REPORT OF COMPLIANCE EVALUATION INSPECTION  
(CONSTRUCTION STORM WATER)

**Glynn Village Plat 10**

Iowa General NPDES No. 2: IA-9433-9235

U.S. ENVIRONMENTAL PROTECTION AGENCY

**Figure 1**

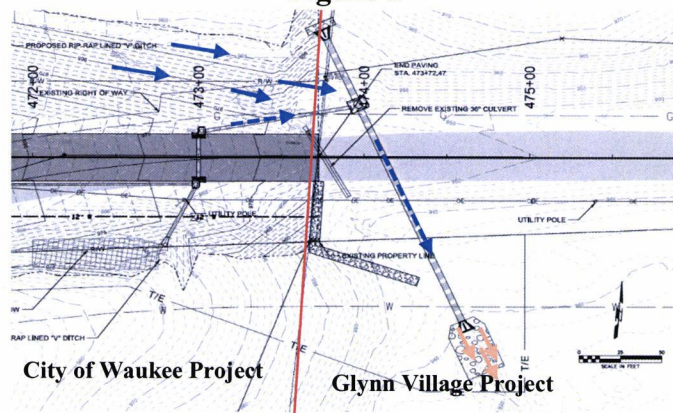
20. I continued walking west approximately 120 yards along the south side of the elevated roadway until I reached another outlet pipe (#10). This outlet has significant sediment accumulation on the ripraps as shown in DSCN1816. The flow to this outlet is mainly from its inlet located in the north ditch (#10). The majority of sediment in the ditch is mainly from the "borrow" area mentioned above and the disturbed north ditch as shown in

DSCN1821-1822. In addition there is sediment coming into inlet #10 from the adjacent City project as shown in Figure 1.
